CENTRAL RESERVOIR REPLACEMENT PROJECT

Final Environmental Impact Report
SCH #2018042078

Prepared for
East Bay Municipal Utility District

TABLE OF CONTENTS

Figure 2-4
Proposed Central Rate Control Station Replacement

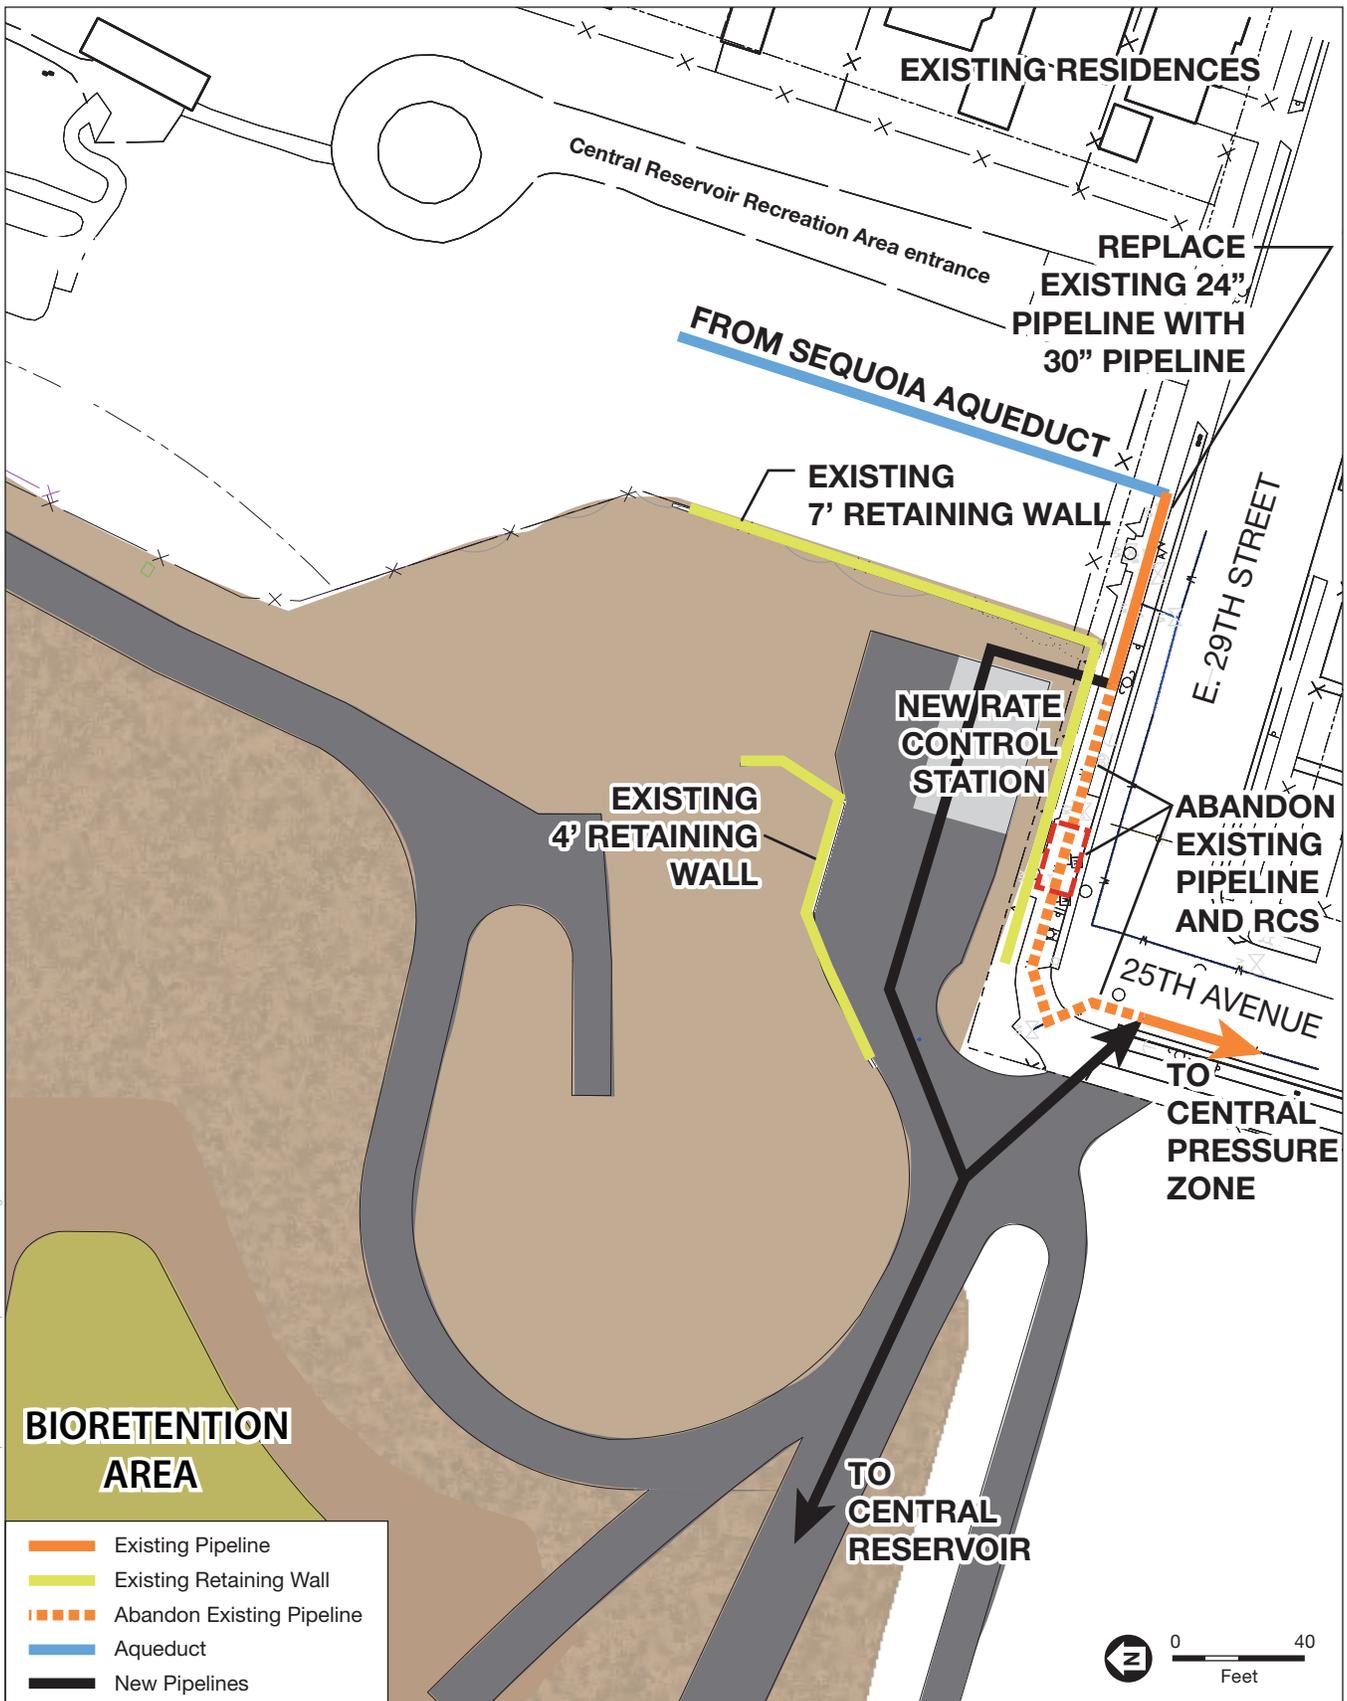
Page 2-7, Figure 2-4 has been revised as shown below to clarify and make easier to read.
